# DEVELOPMENT REVIEW BOARD REPORT

SUBJECT	<b>Rio Verde Estates</b>
REQUEST	<p>Request Preliminary Plat approval for a 23 Lot Single-Family residential subdivision with amended development standards on a 50+/- acre parcel.</p> <p><b>23-PP-2004</b></p> <p><b>Key Items for Consideration:</b></p> <ul style="list-style-type: none"><li>• This is a new development/subdivision and is proposed on undeveloped vacant land with minimal impact to neighboring properties.</li><li>• This property is located in the upper desert landform and will be developed with a minimal amount disturbance and a maximum amount of preservation to the natural desert.</li></ul>
OWNER	<p>DBR Development 760-728-4343</p>
APPLICANT CONTACT	<p>Len Erie Erie &amp; Associates 602-954-6399</p>
LOCATION	<p>13201 E Rio Verde Drive</p>
BACKGROUND	<p><b>Zoning.</b></p> <p>The site is zoned Single Family Residential District, Environment Sensitive Lands (R1-70 ESL). The R1-70 zoning district allows for 70,000 square foot lots or larger. The surrounding property is zoned Single Family Residential District R1-70 ESL along the sites immediate borders. One half mile south and west of the proposed site is zoned R1-130 ESL and R1-19

RIO VERDE ESTATES  
PRELIMINARY PLAT

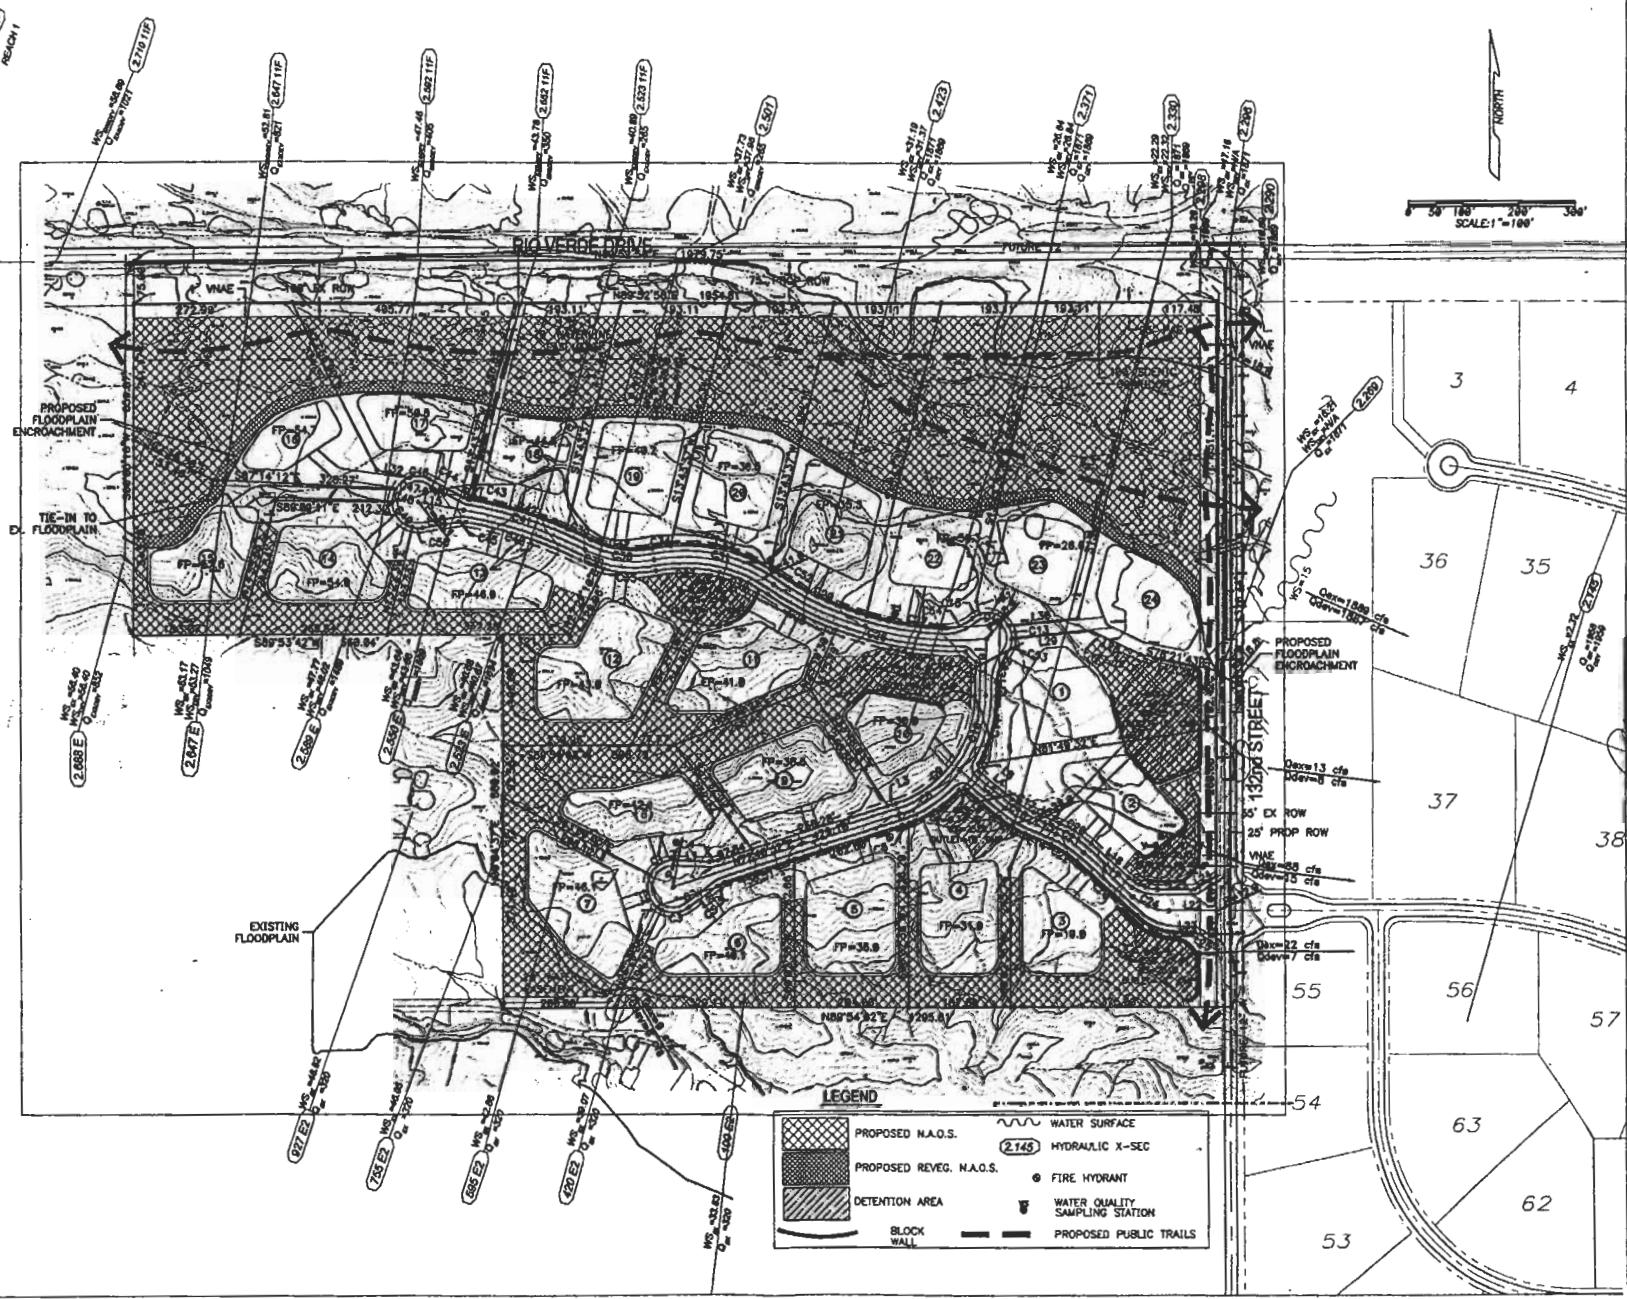
1. The improvement plans and plat shall be in substantial conformance to the following documents except as required by the Revised Scottsdale City Code, and the stipulations herein:

- a. The location and configuration of all site improvements shall be constructed to be consistent with the Preliminary Plat submitted by Erie & Associates, INC., dated 12/29/2004 by City staff.
- b. The Design Standards and Policies Manual (DS&PM).

6. The minimum total NAOS to be dedicated for this project shall be 19 acres.
7. Wash Modification shall be approved prior to final plans submittal.
8. Add the following note on final plat: This plat has dedicated a total of 19 acres of NAOS. Natural Area Open Space as dedicated by this plat shall never be released or reduced unless equal size and quality NAOS area is provided

- Q. The NAOS dedications shall not be accepted within roadway easements or row. The NAOS graphic shall be revised to exclude all areas within the existing roadway easements, unless an abandonment of said easements is approved through the City Council.
- R. The maximum allowable revegetated NAOS shall not exceed 30 percent of the total NAOS to be dedicated.
